# **Technical Bulletin**

**2023-012**

**Change of the PTP screws of Eurosit**

July, 2023

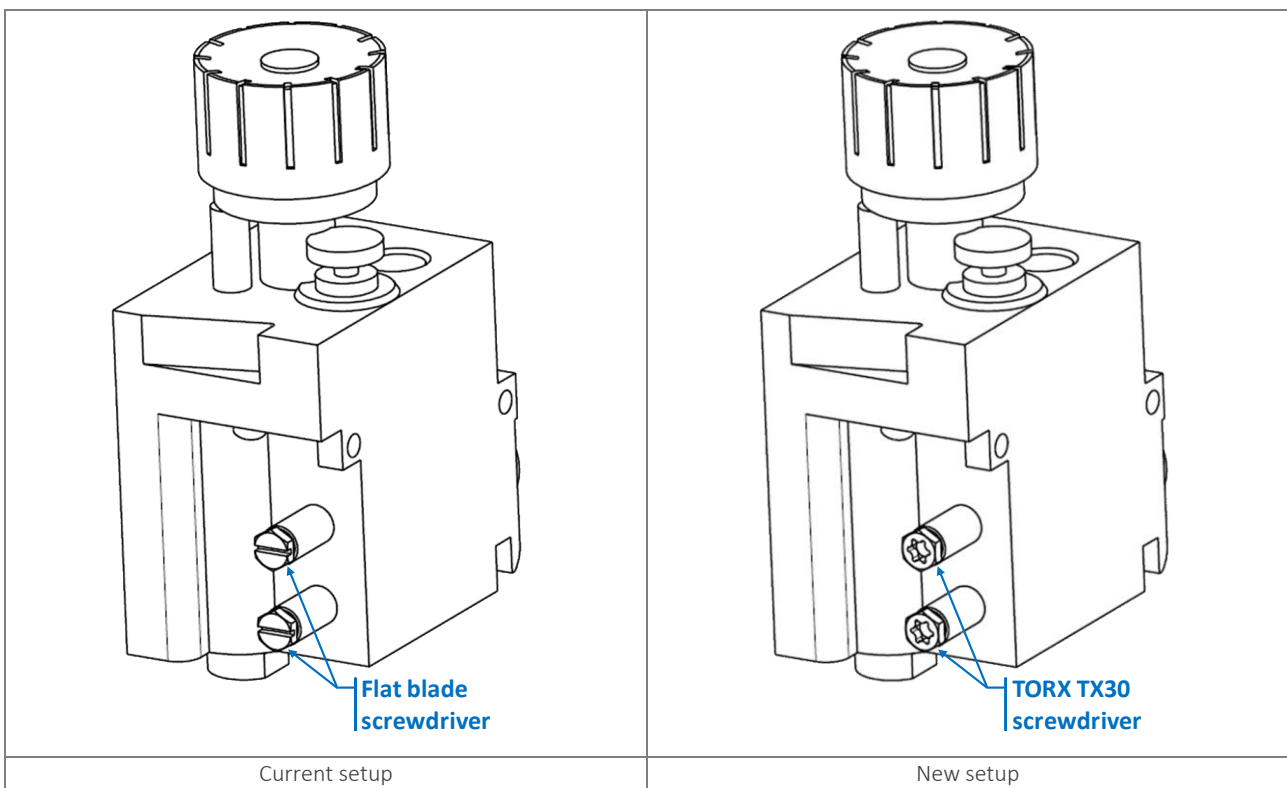
We inform you that, with the aim of improvement of the product and of the production process, we planned to change the pressure test point screws (PTP screws) of some codes of Eurosit: the change is shown in the below pictures. The screws are classic hexagonal and in the current version, they allow the handling also with a flat blade screwdriver. With the new version, a TORX TX30 screwdriver shall be used in place of the flat blade.

The introduction of the new screws is foreseen to be implemented within November 2023.

No changes in performances, specifications, or codes are going to be introduced.
